C32 PREAMPLIFIER

SERVICE INFORMATION

CORRECT POSSIBLE SHORTING CONDITION

SERVICE BULLETIN

HEADPHONE MONITOR PC BOARD

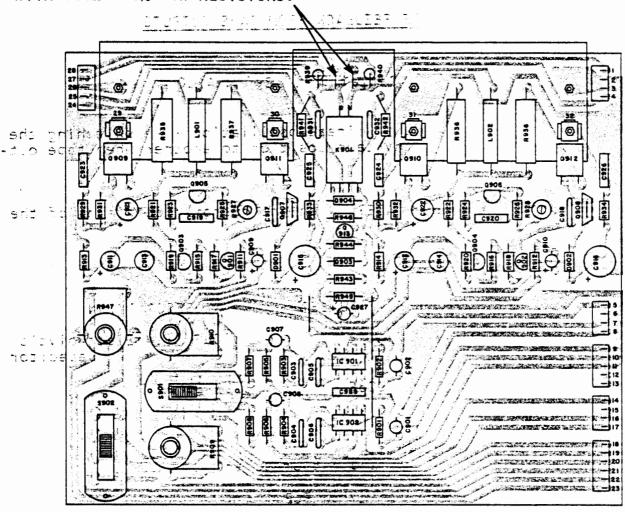
PURPOSE OF MODIFICATION: To correct the condition where by the preamplifier's headphone amplifier channels are shorted together when plugging headphones into the top headphone jack.

- 1. Remove top cover.
- 2. Make a sketch of the connectors connections to the headphone monitor PC boards.
- 3. Remove the connectors from headphone monitor PC board and remove headphone monitor PC board from the chassis.
- 4. Replace jump wire that jumps K901 to connector pin 28 with a 136453 100Ω 10% 1W resistor.
- 5. Replace jump wire that jumps K901 to connector pin 24 with a 136453 100Ω 10% 1W resistor.
- 6. Reinstall the headphone monitor PC board and replace top cover.

REMOVE JUMPERS AND REPLACE WITH 100Ω 10% 1W RESISTORS.
